Tree and Landscape Officer Comments dated 3rd August 2023

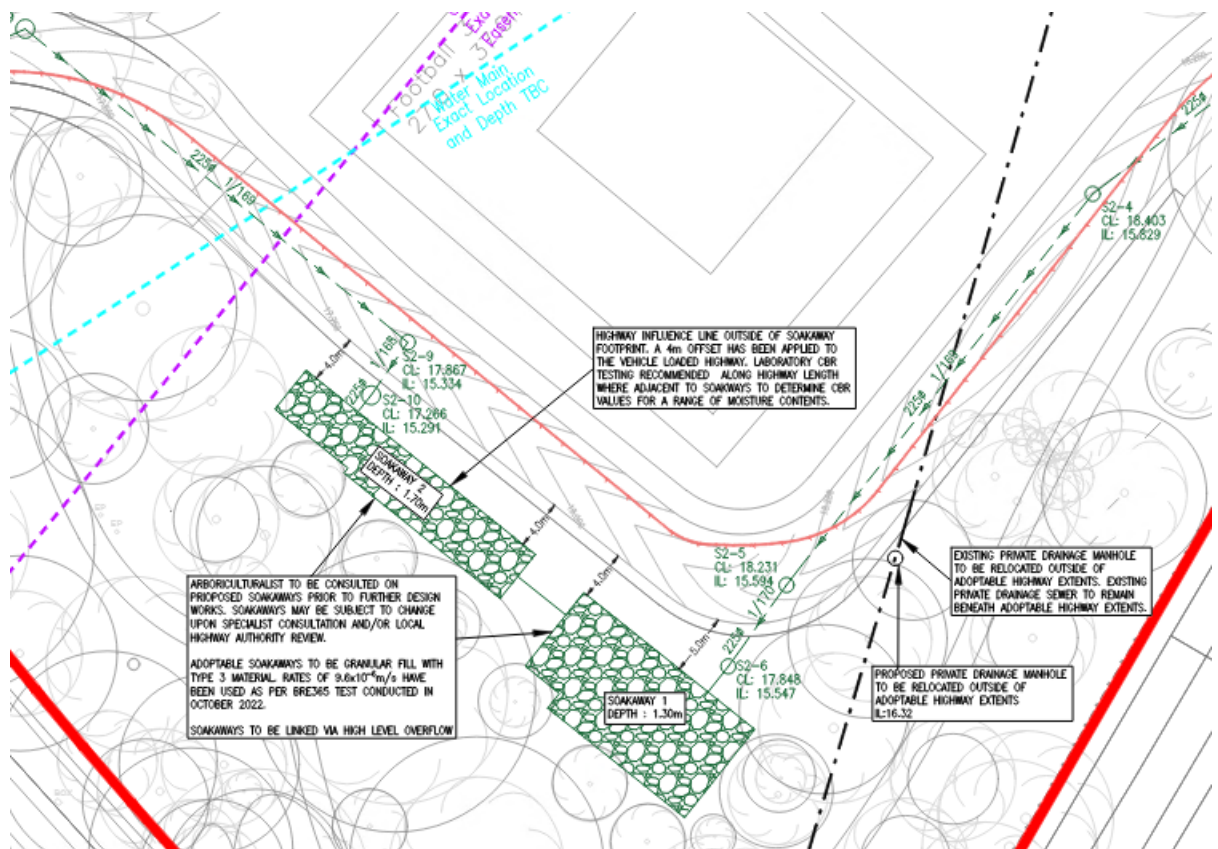
The part of the above statement *“final design of these soakaways would be subject to further investigation”*. The design is not complete, BS 5837 addresses tree and construction, it does not address hydrology or SUDs. This will fundamentally change the hydrology of the adjoining woodland and potentially bring the woodland soil into an anaerobic state. A screen snippet within the committee report and below taken from drawing received June 14th 2023 clearly shows construction within the RPA.

In response, the most recent drawing received 14 June 2023 (again see snippet in the report) shows construction is within the RPA, clearly stating it may be “subject to change”. There is no assessment of the full impact on the trees. The Arb assessment 3 April 2023 fails to fundamentally address the percolation and drainage rates through the woodland. Given the potential impact and loss of trees it is inappropriate to deal with by condition due to the potential negative impact on trees.

8. TPO retained trees, as previously stated and shown in the screen snippet shows the proposal does interact within the RPA of retained trees. The development does not take into account future growth of trees, fundamentally changing the character of the area.
